September 26, 1968
HW-16 Novice Transmitter
Bulletin No: HW-16-1

September 9, 1971
HW-16 Novice Transmitter
Bulletin No: HW-16-2

**SCHEMATIC OF THE
HEATHKIT®
CW TRANSCEIVER
MODEL HW-16**

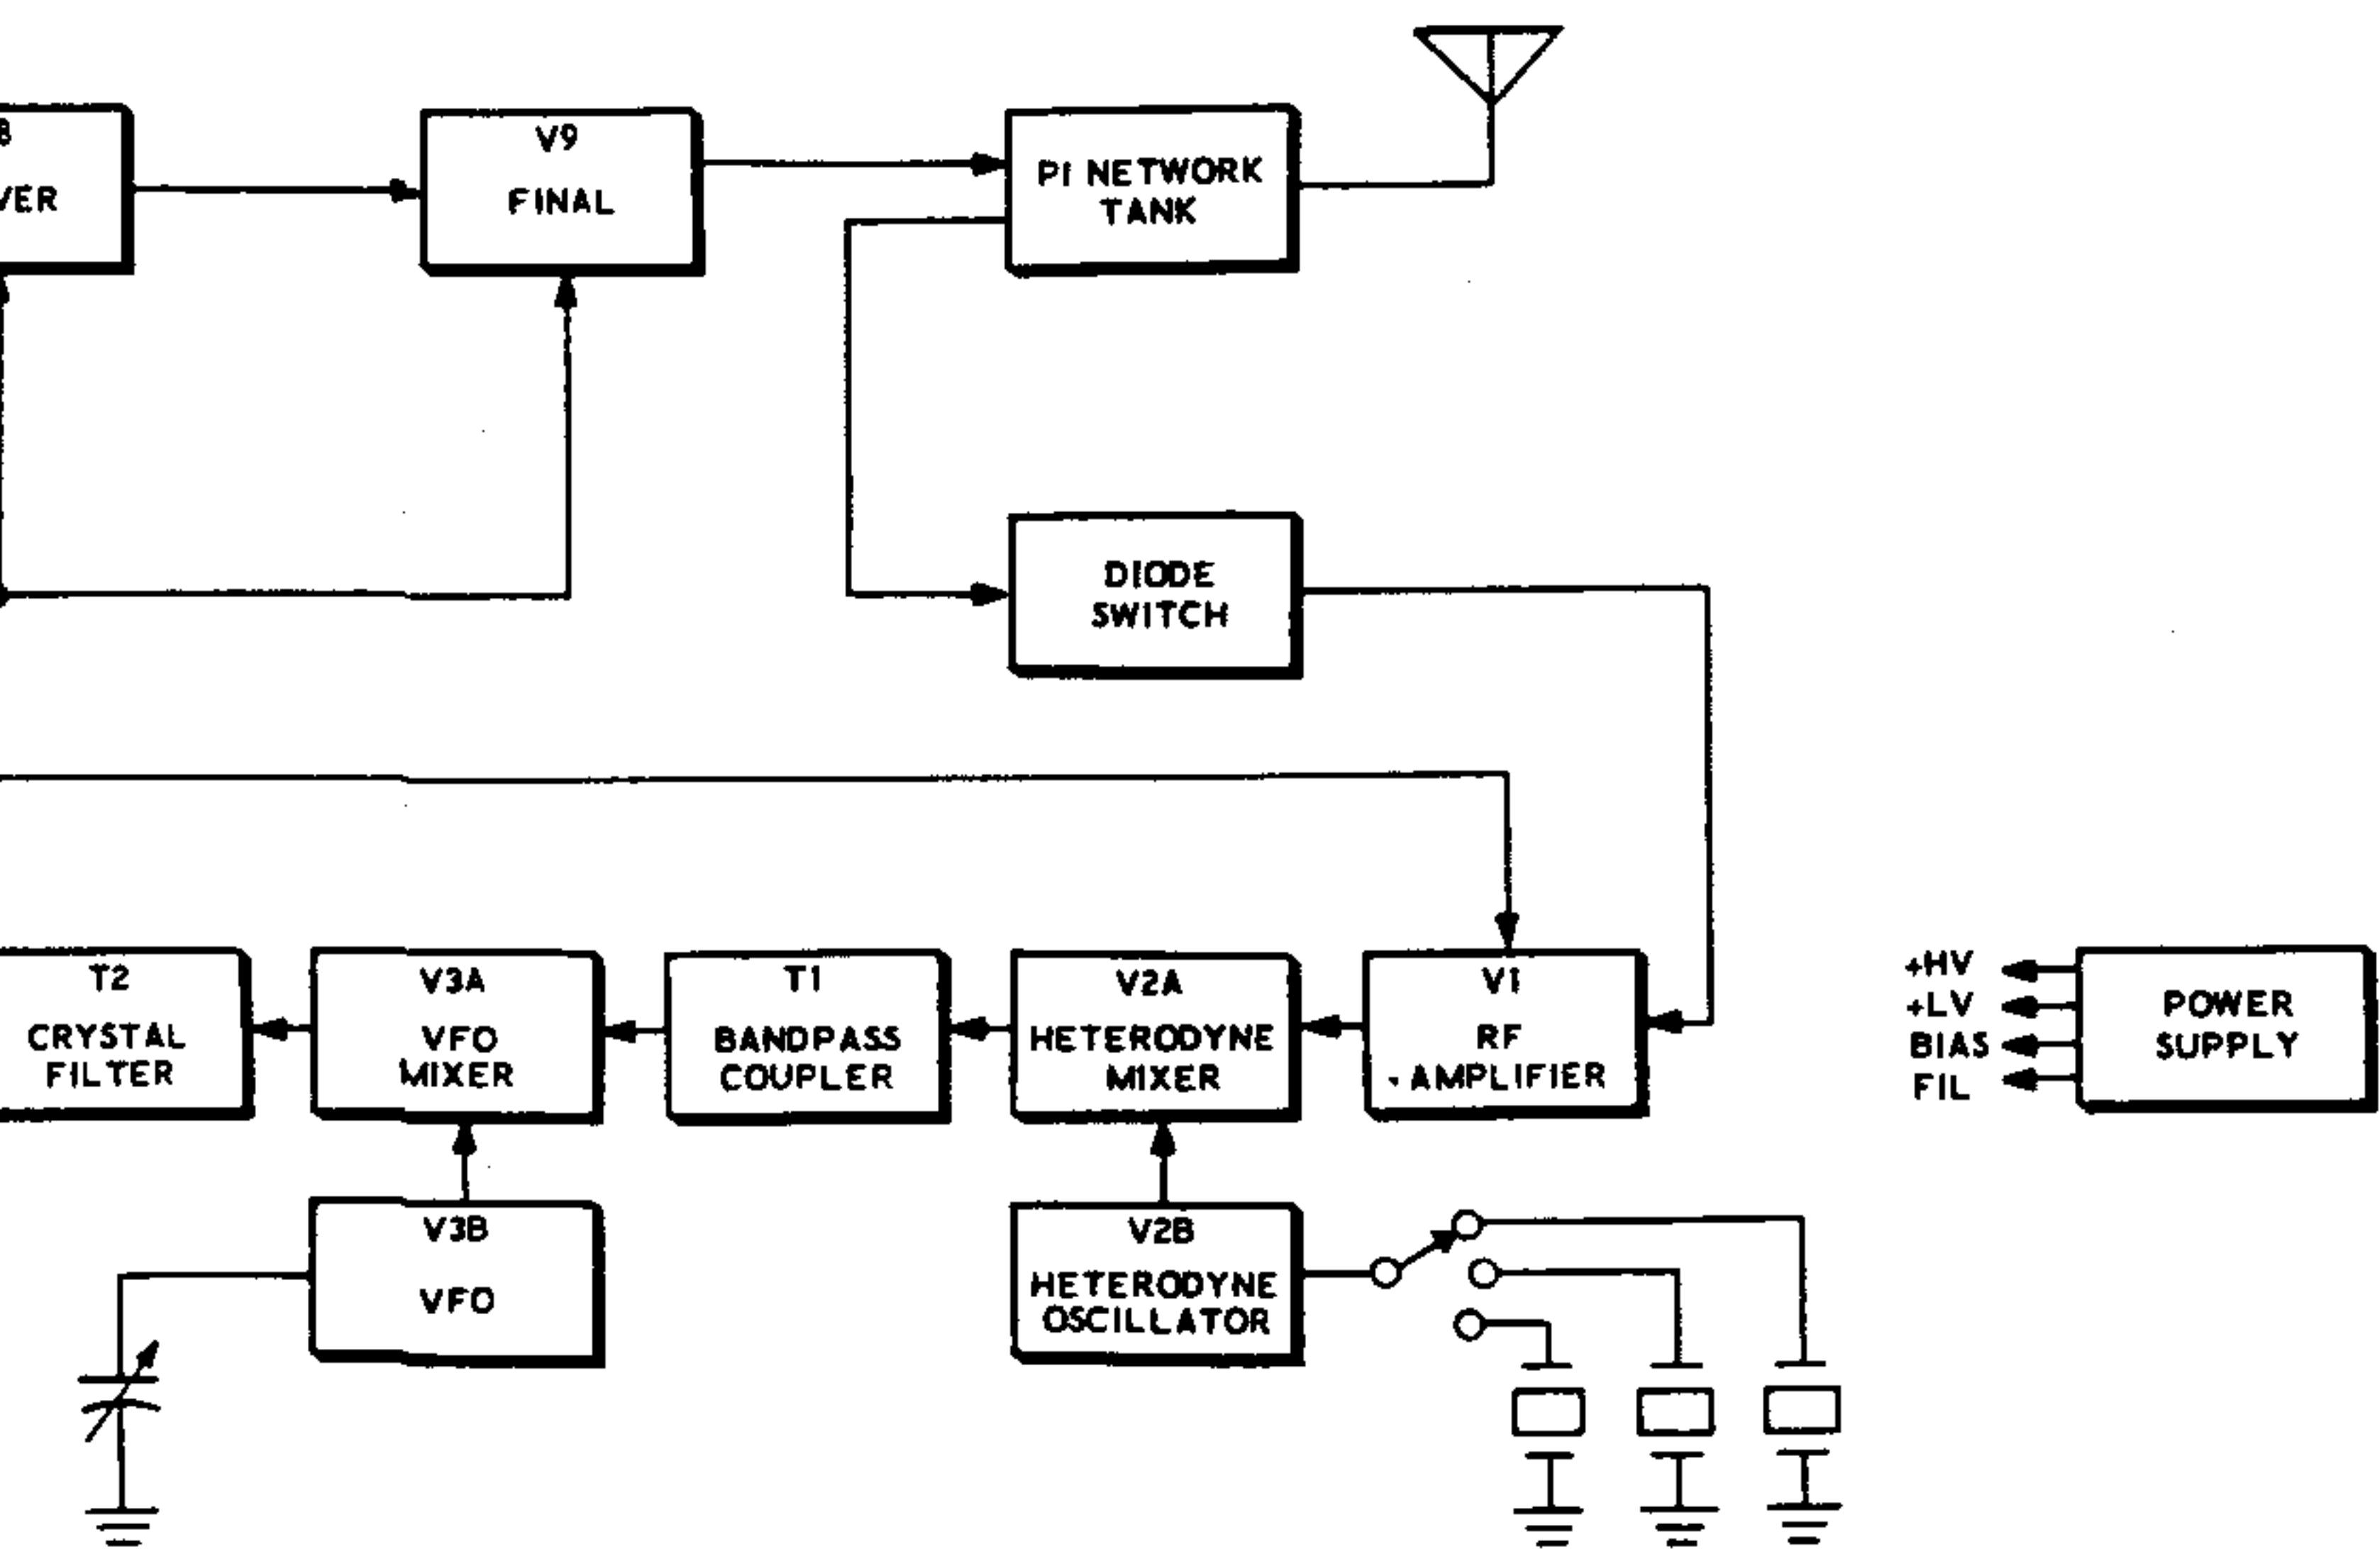
Side Tone

When using the HW-16 with a VFO sometimes a partial operation of the sidetone oscillator takes place due to an increased loading on the bias voltage. This can be corrected by changing R-69 from a 120K ohm resistor to a 220K ohm resistor [PN 1-29]. Also, the original schematic shows R-16 as a 4700 ohm resistor which is incorrect. R-16 should be shown as a 5600 ohm resistor.

Resistor Failure

Due to repeat failure of a resistor in the field, the following change should be made in all units being serviced:
CHANGE: R21 22K 1 Watt to 2 Watt [PN 1-11-2].
